TECHNICAL INFORMATION

74190

September, 2005

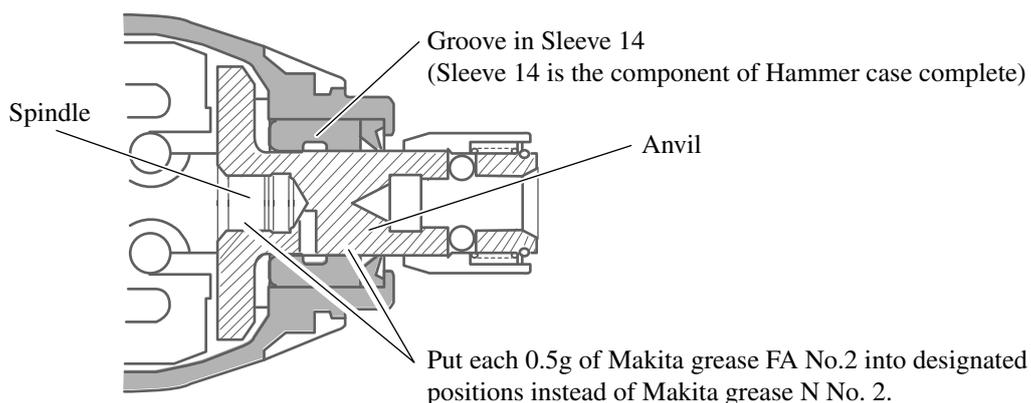
- Subject** ▶ Addition of Groove in Sleeve 14,
Change of Grease
- For Models** ▶ BTD130F, BTD140
- Country** ▶ All countries
- Description** ▶ Regarding Sleeve 14 of Hammer case complete, a groove for grease has been added.
Makita grease N No.2 has been replaced by Makita Grease FA No.2 for lubrication between;
1) the sleeve 14 and Anvil.
2) one end of Spindle and depression of Anvil.
See illustration below.

Item No.	Current part		Q'ty	I/C	New part		Q'ty	Note
016	Hammer Case Complete 154590-6		1	←	Hammer Case Complete 154590-6		1	The part No. remains the same.
—	Makita Grease N No.2 (16Kg) 042005-4A		4g		Makita Grease N No.2 (16Kg) 042005-4A		3g	The required amount has decreased due to addition of Makita grease FA No.2.
—					Makita Grease FA No.2 (2.5Kg) 042025-8A		1g
